GENERAL MOTORS
DCS7504
URGENT - DISTRIBUTE IMMEDIATELY

Subject: REVISION: N262547330-01 – Service Update
Telematic Control Module Reprogramming
Revised Warranty Table, Service Procedure & Additional Vehicles
Added

N262547330 Telematic Control Module Reprogramming

Revision: 02

SPS Warranty Claim Code:

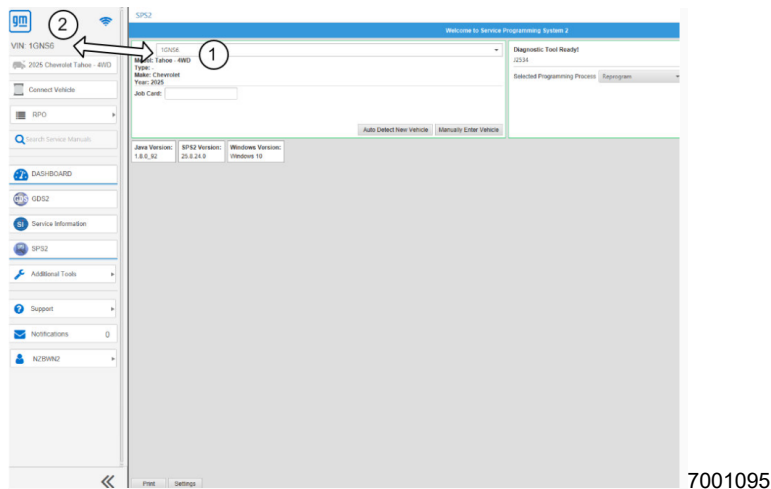
- The Warranty Claim Code from the programming event must be accurately entered in the “Warranty Claim Code” field of the transaction.

- When more than one Warranty Claim Code is generated for a programming event, it is required to document all Warranty Claim Codes in the “Correction” field on the job card. Dealers must also enter one of the codes in the “Warranty Claim Code” field of the transaction, otherwise the transaction will reject. It is best practice to enter the FINAL code provided by SPS2.
- For more information about Warranty Claim Codes and retrieving a lost code, refer to *25-NA-281 Information on SPS Warranty Claim Code Submission and Retrieval* in SI.

Same Calibration Screen

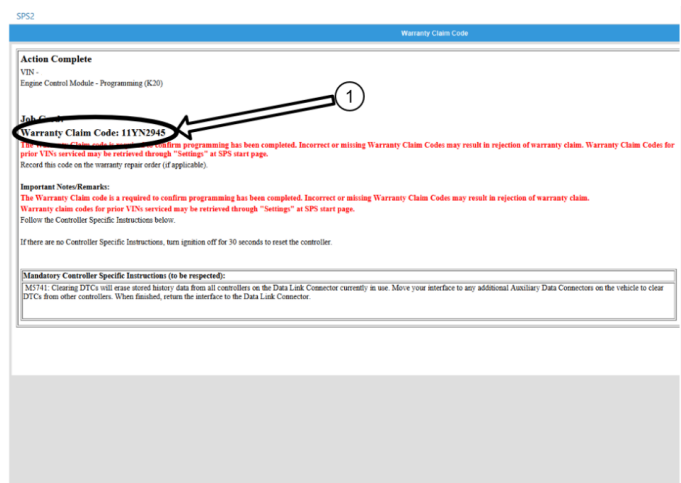
- 5.1 If the same calibration screen above is shown, select OK and continue to Step 6. If the screen above is NOT shown, continue to Step 5.2.
- 5.2 Continue to reprogram the Telematic Control Module until the screen above is shown and select OK. The module may be several software versions behind and could take multiple programming events to bring it to the latest software level (**The same calibration screen MUST be displayed to validate the module has been programmed to the latest level**).

Important: To avoid warranty transaction rejections, you **MUST** record the warranty claim code provided on the Warranty Claim Code (WCC) screen shown above on the job card. Refer to callout 1 above for the location of the WCC on the screen.
